RESPONSE TO COUNCIL RFI

Area 5

13-19 Canberra Avenue
St Leonards South NSW 2065

Prepared for
HYECORP

1. HEIGHT OF BUILDING

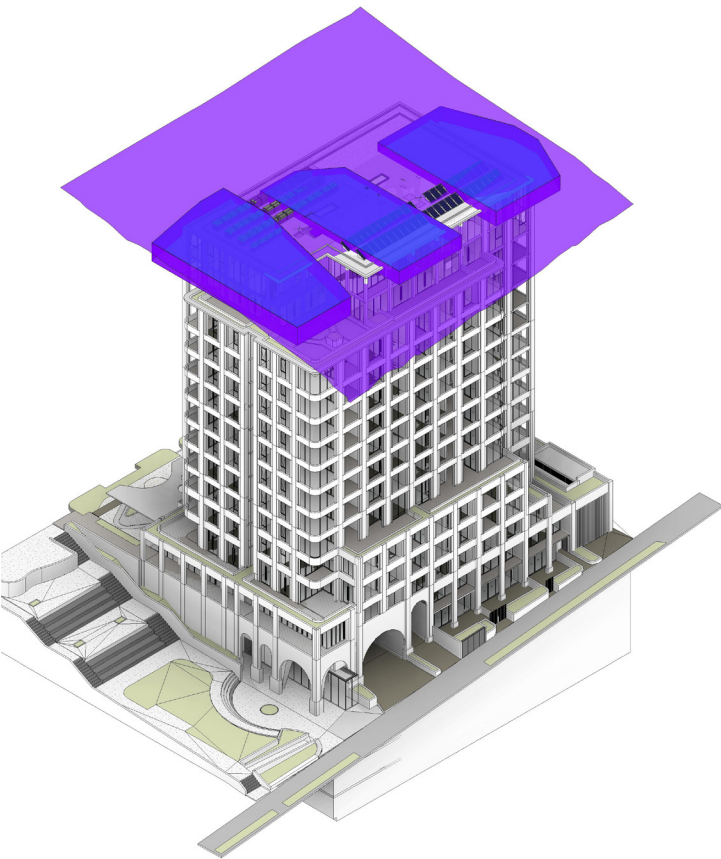
- The proposed height of building exceeds the incentive building height provision of LCLEP 2009.

1. The DA submission had limited minor non compliance to small parts of the eastern edge of the upper storey.
The building height has now been reduced to fully comply with the height provision.

3. STOREYS

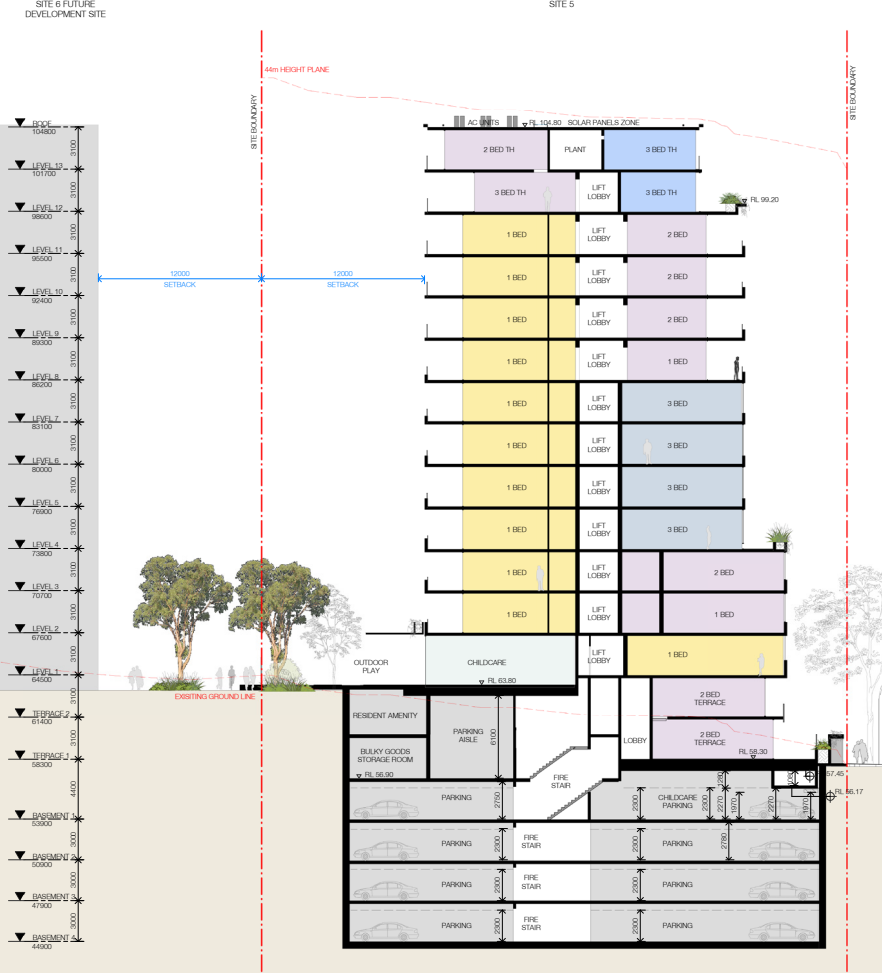
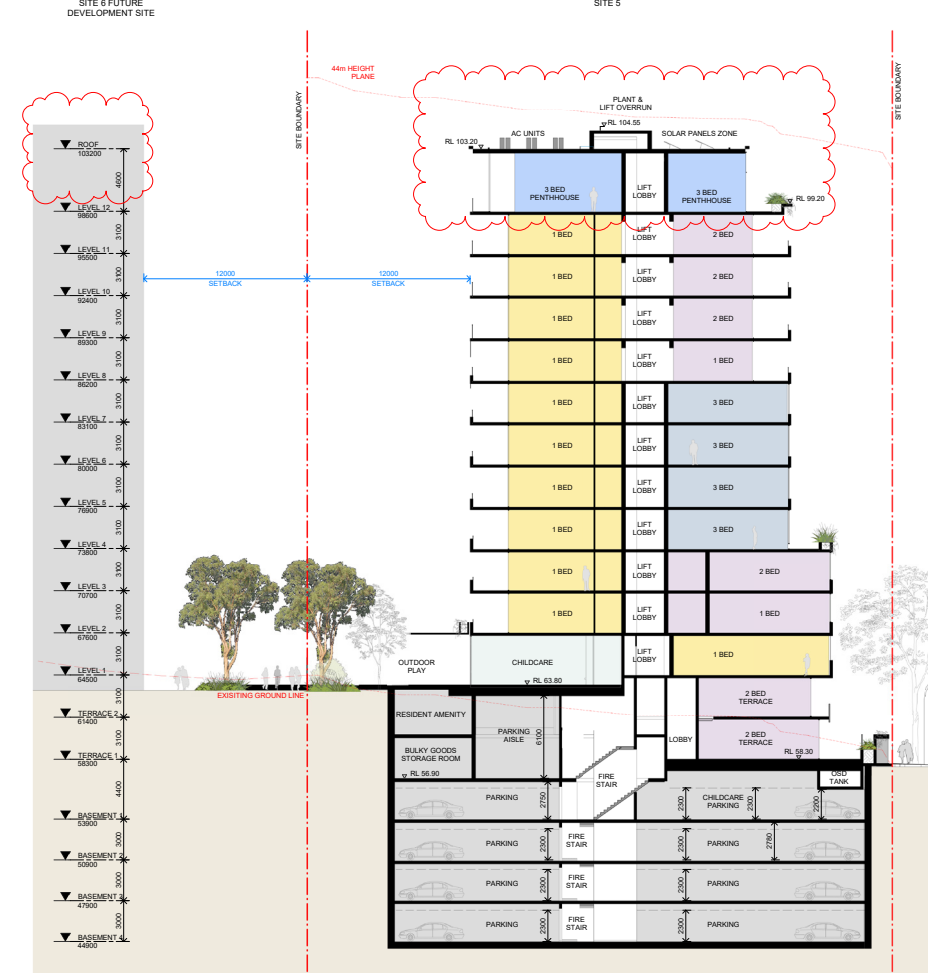
- The proposed development contains 13 storeys and 2 part storeys. LCDCP 2009 Part C Residential Localities – Locality 8 – St Leonards South Precinct allows for a maximum of 12 storeys in Area 5. You are requested to amend the proposal to comply. The resulting rooftop could be better utilised for a larger communal open space.

- The DA submission aimed to provide the envisaged housing target setout by the masterplan while minimizing the building form impact to the surroundings community open space. Being a 13 storey or 12 storey building does not change the envelope of the building drastically, nor does it have any additional shadow impact to the open spaces. However, the applicant embraces the community expectation and the LCDCP storey control, the updated proposal has reduced the rise in storeys to 12.

- The communal open space is still best situated on L12. The roof space is filled with services, ducts, AC units and solar panels, which make the environment unpleasant and not suitable for the residents use.

- The proposal has 4 distinct opportunities and large areas for resident to engage and enjoy the community and communal open space within the development. These include; the rooftop communal open space with uninterrupted city views; the programmed Upper Ground indoor community facility; after hour/weekend use of the expansive childcare outdoor play area and vast communal open spaces at the precinct level, including the green spine, east west link and Newlands Park.

4. BUILDING SETBACKS
A. PEDESTRIAN LINK SETBACKS

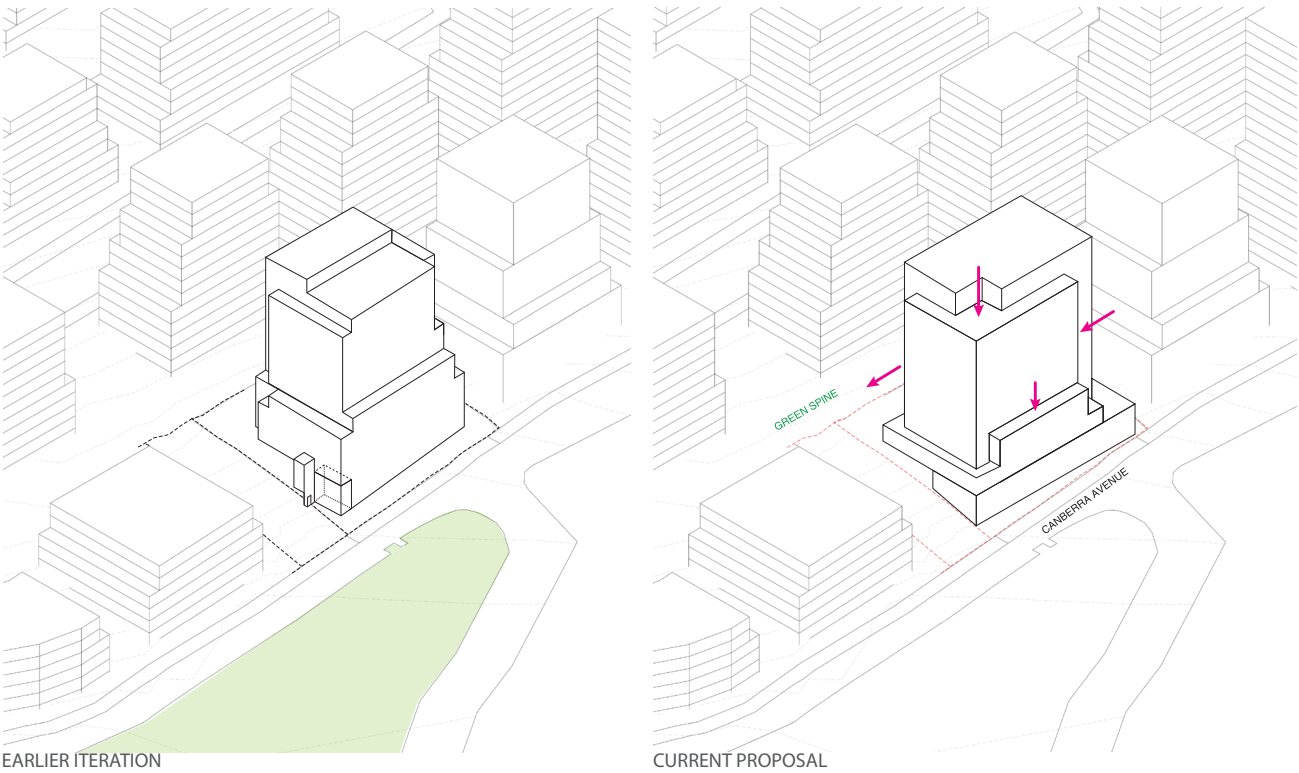
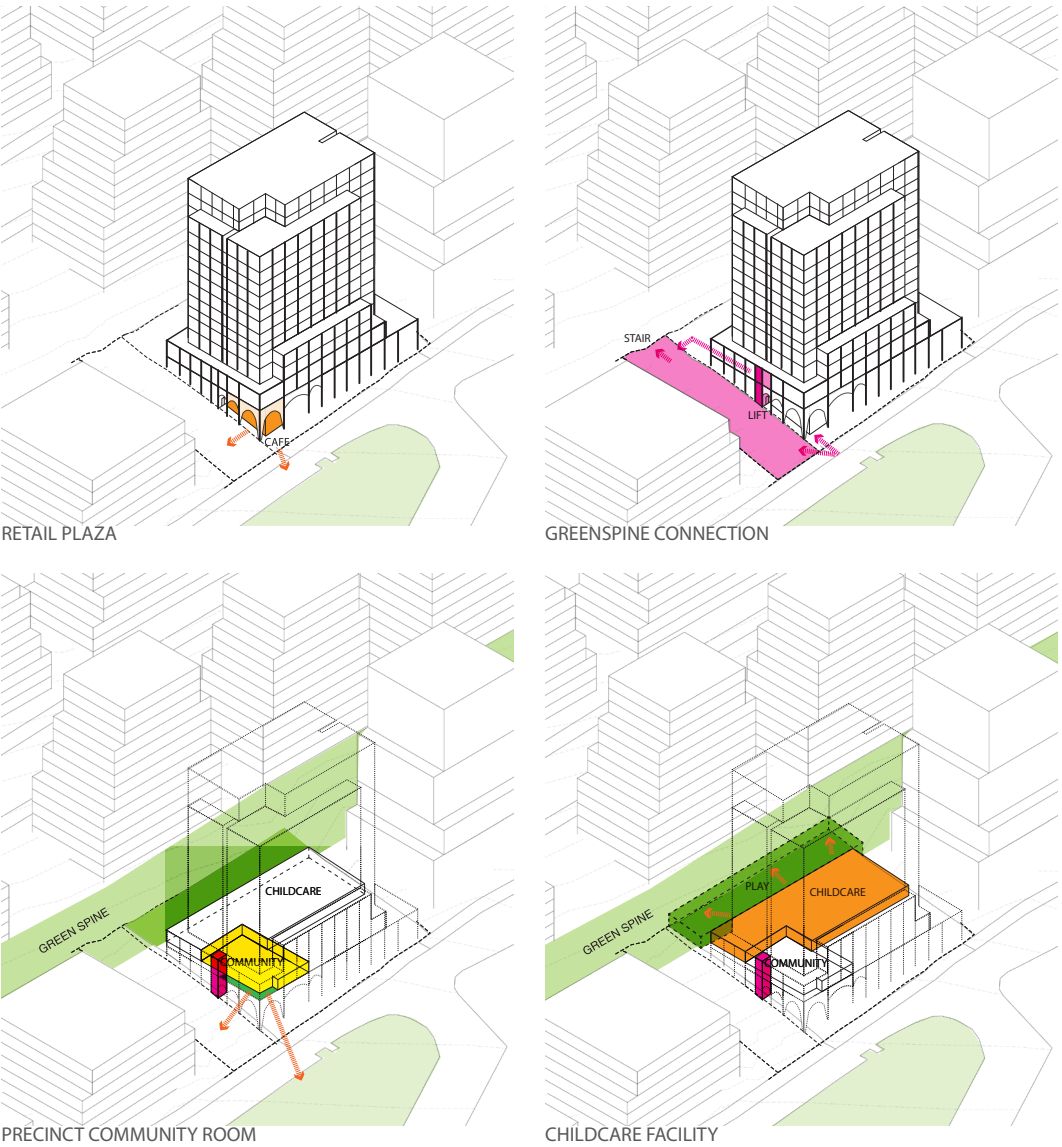
- The proposal seeks to depart from the pedestrian link setbacks established in the DCP as detailed in Table 1 below.

Storey	Required Setback	Proposed Setback
1-4	6m	Predominantly 0m
5+	9m	Predominantly 3m

- Recent determination DA99/2021 has reinforced the provision of compliant setbacks to the pedestrian link. For example, Building 8 (Area 8) provides a 10 storey building, similar in scale to the proposed development, with compliant pedestrian link setbacks. The proposed setbacks are considered to provide unsatisfactory bulk and scale impacts on the link and future public domain and are requested to be amended to comply.

1. The current building form is generated through multiple discussions with the council and design excellence panel. The initial massing had the southern facade setback from the pedestrian link. However, it was agreed between the council and the panel that the public lift and amenity needs to be a part of the main building envelope, therefore the building envelope can encroach into the setback towards the pedestrian link. The panel and council also encouraged the massing to be shifted from the Northern to the Southern facade, to provide more separation to the future northern tower. As the pedestrian link is within the applicant boundary, and the lower massing of the tower contains predominantly public amenities, including, retail corner, public lift, community room and childcare center, shifting the massing closer to the east west link provides more interaction between the public shared spaces, more opportunities for street surveillance, which was the agreed and preferred design excellence outcome. Moreover, the setback at podium levels will result in a tall boundary wall due to the significant level change, and therefore unpleasant and unsafe dark spaces between the pedestrian link and the building facade, which will be a poor outcome for the development and the precinct. The current proposal is a result of careful consideration of the particular building location, the surrounding environment/functions and the site specific topography conditions.

4. BUILDING SETBACKS
B. CANBERRA AVENUE SETBACKS

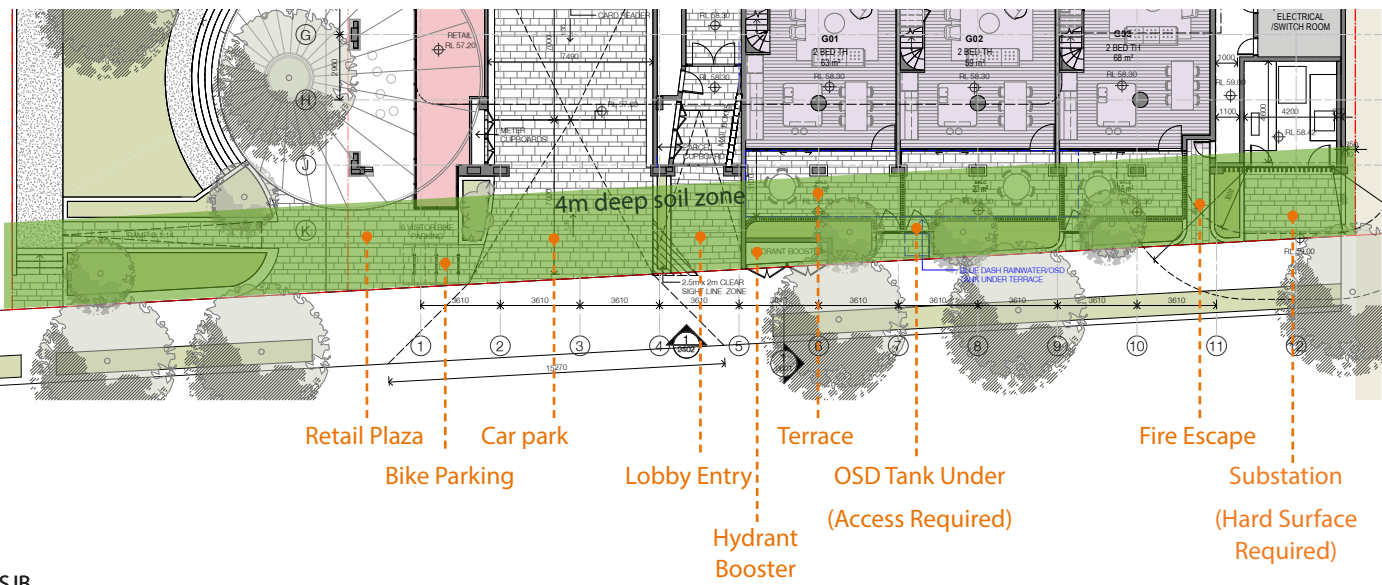
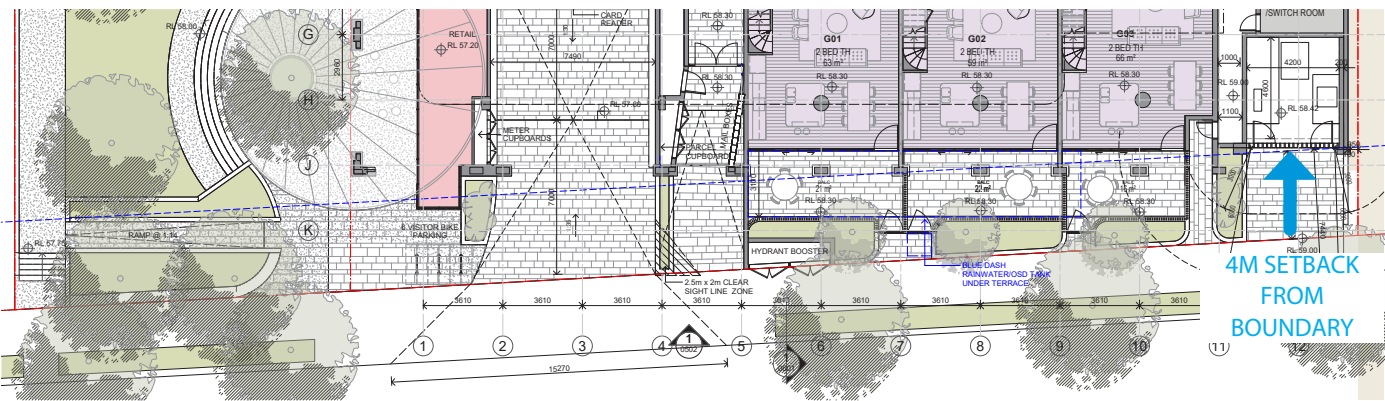
- The proposal seeks to depart from the provision of a minimum 4m deep soil zone to Canberra Avenue through the proposed basement encroachment as detailed in Table 2 below. The basement should be set back to afford the opportunity for deep soil landscaping to Canberra Avenue.

Required Setback	Proposed Setback
4m	0m - 2.5m

- The proposal seeks to depart from the provision of a minimum 4m building setback to Canberra Avenue.

Storey	Required Setback	Proposed Setback
1-5	4m	2.7m - 4.3m
6+	7m	7m

- Consideration should be given to providing full compliance for the podium of the building to Canberra Avenue. In particular the plant/kiosk area at 2.7m adjacent to the adjoining property does not assist in a consistent podium setback to Canberra Avenue.

1. The provision for the minimum 4m deep soil zone to Canberra Avenue is to ensure an adequate separation between the streets and the building, and sufficient tree canopy achieved throughout the development. The scheme has a significant landscaped pedestrian link across East and West, which provides ample landscape opportunity for the site. Canberra Avenue is the sole street frontage to the building, various programs need to be placed along it to ensure the functionality of the building, Including the activated retail plaza, car park entrance, building lobby entrance, fire booster cupboard, access to rainwater and OSD tank under, entrances and terrace space for the ground floor residences, and hardscape surfaces to the substation. Deep soil zone in those areas is inefficient and redundant. The proposal provides landscaped area wherever possible, including in front of the residences to provide separation and privacy protection from the street. Raised landscaped areas between each change of program, for example between the driveway to the retail plaza and lobby area.

2. The boundary of the site is parallel to the street, it is not desirable to rotate the building and achieve the 4 m setback along Canberra avenue consistently. The applicant has pushed back the substation further to achieve the 4m setback required by the council.

5. BUILDING SEPARATION

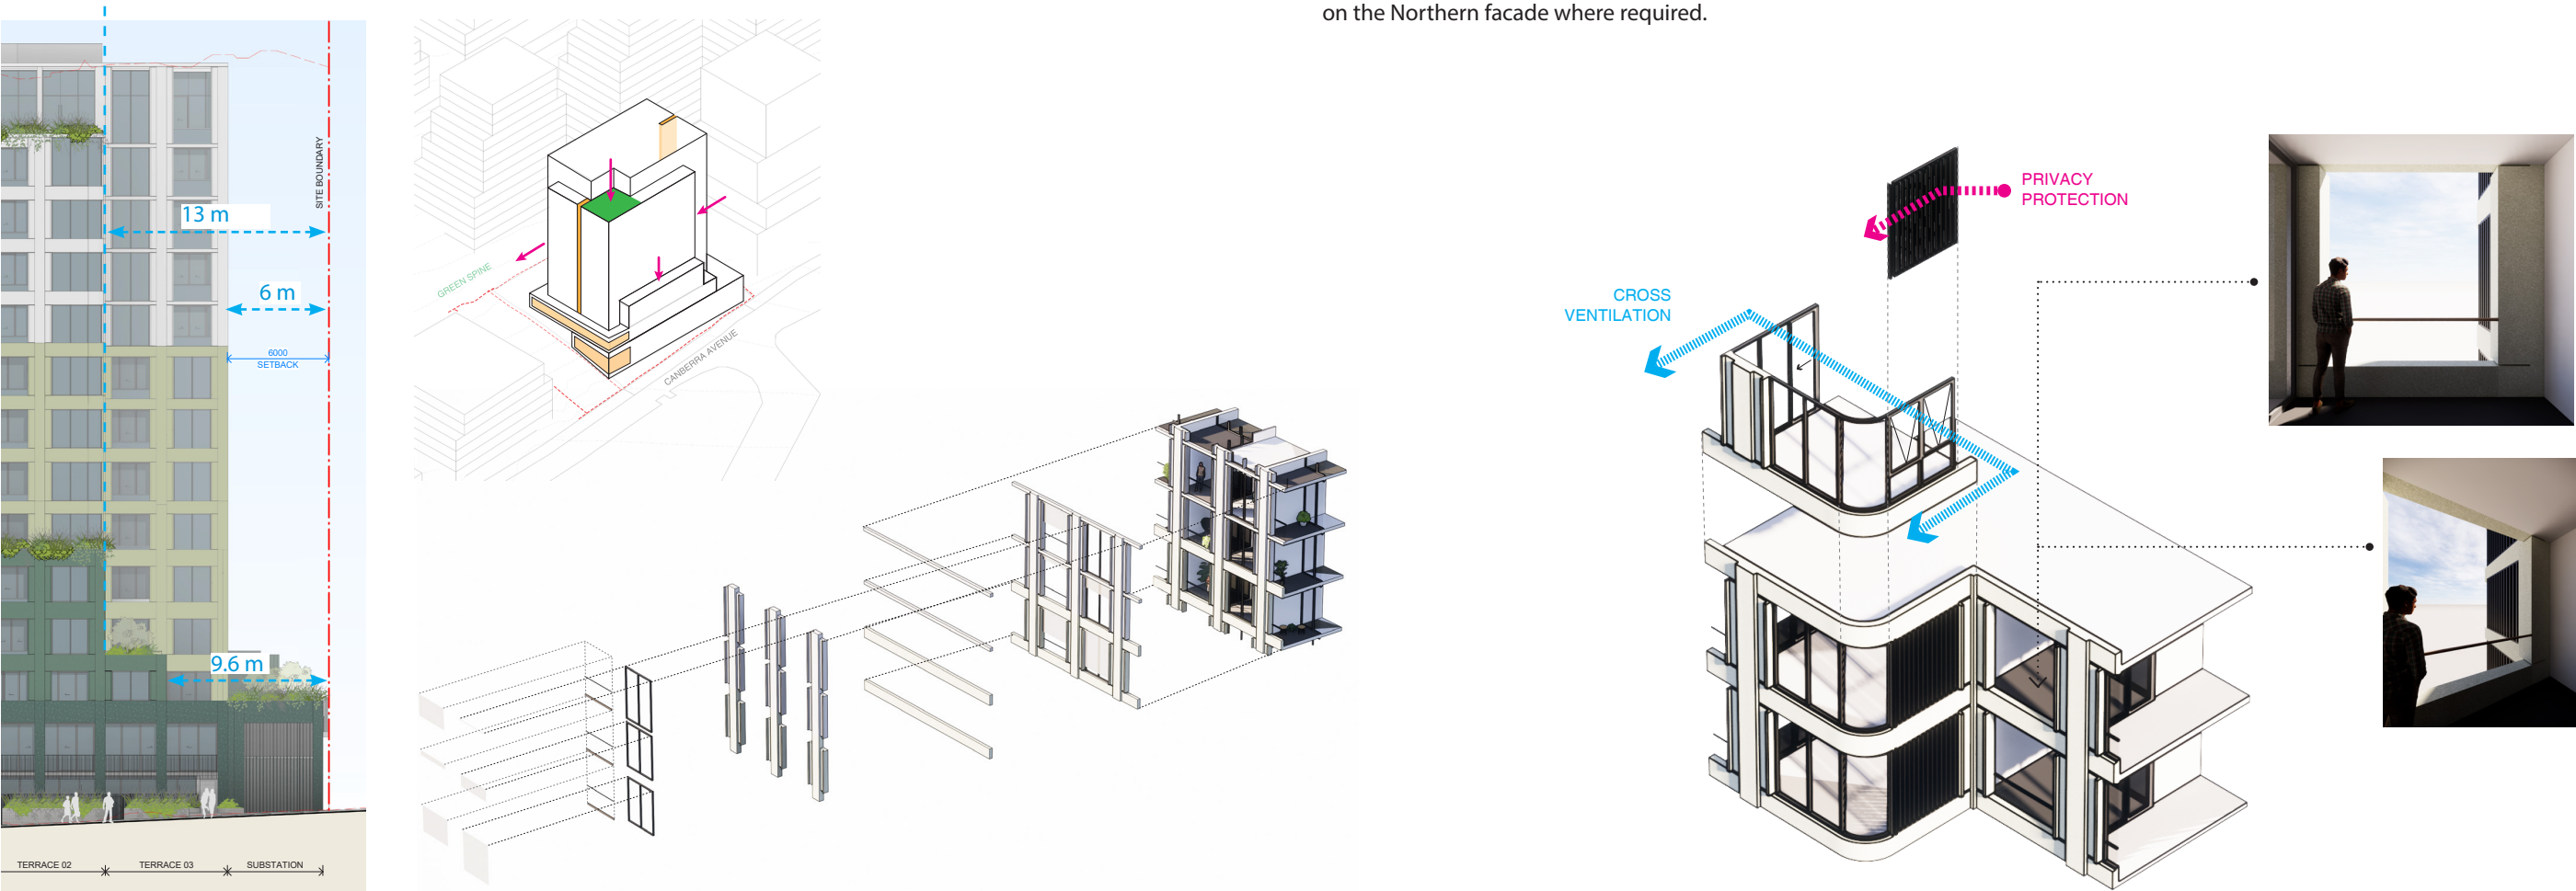
- The proposal seeks a departure from the habitable building separation standards within the Apartment Design Guide to the northern boundary without sufficient detail on how these non-compliances will be addressed through design measures or clear explanation of how they are blank-wall or non-habitable interfaces (i.e. the SEPP 65 detail from the architect is insufficient). Any justification is to detail how the design would not preclude future development in Area 3 from developing to the minimum habitable building separation distances in the future

1. Visual privacy of the ADG provides minimum building separation distances between buildings as a guide to better manage the interfaces between 2 developments. The proposed design provides for these conditions through appropriate building separation resulting from the design excellence process and suitable facade treatment.

2. The proposal had gone through a number of iterations throughout the design excellence process. One key consideration to the building form was to break up the massing to the north and shift part of the volume towards the South to provide more separation to the future development. The separation between the building envelope to the Northern boundary varies from a min of 6m, 9.6m to 13m. Coupled with the proposed treatment of habitable/non-habitable interfaces at the Northern facade, the proposed building separation complies with the requirements of the ADG.

3. The apartment layout design for that facade interface was also setout to provide dual aspect apartments on the northern corners, to provide a predominant outlook towards the green spine and Canberra Avenue. The adjacent development in Area 3 will have south facing apartments at that interface, it is therefore more desirable for those apartments to be dual facing as well, to maximise the solar access and direct the view out to the parks instead of the building facade. This treatment would comply with the building separation requirements of the ADG.

4. The facade design also enables a more protected living space with it's oversized columns, solid horizontals and privacy screening on the Northern facade where required.
